UNITED STATES
NUCLEAR REGULATORY COMMISSION
WASHINGTON, D.C. 20555-0001

SUBJECT: TECHNICAL REVIEW: UPDATE ON PROJECTED TECHNETIUM
RELEASE FROM SALTSTONE

Technical Review: Update on Technetium-99 Release from Saltstone

The purpose of this NRC staff Technical Review Report (TRR) is to update the NRC technical position on Technetium (Tc) release from Saltstone at the U.S. Department of Energy (DOE) Savannah River Site (SRS) Saltstone Disposal Facility (SDF). The NRC staff technical position on Tc release had previously been described in two TRRs:

Figure 21. Percent Tc released from four simulated Cast Stone samples as a function of the distance from an outer sample wall exposed to oxic leachate for 569 to 590 days and stored in a closed container for an additional 319 to 393 days (from PNNL-25578 Figure 3-5)

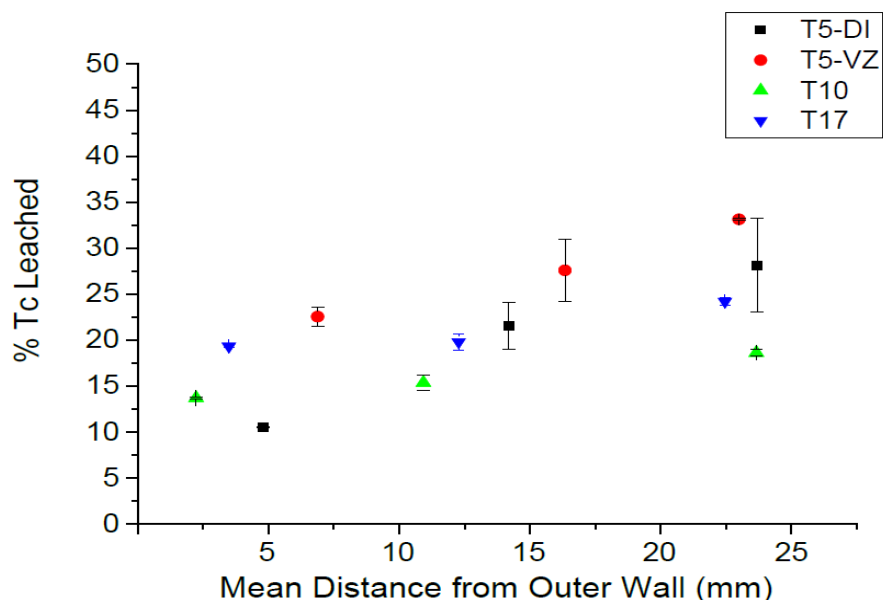
Because the authors of PNNL-25578 used uniform sizes for the majority of sub-samples, the trends in Figure 21 are not correlated with the inverse of sub-sample size as the apparent “Tc-specific oxidation front” is in SRNL-STI-2010-00541 (see Figure 20). The authors of PNNL-25578 compared their results to the results of SRNL-STI-2010-00541 and noted there was, in general, a lower fraction of Tc release in their study, and that the trend of increasing Tc mobility toward the center of their simulated Cast Stone samples was opposite the apparent trend shown in Figure 17. The authors of PNNL-25578 attributed the difference between their results
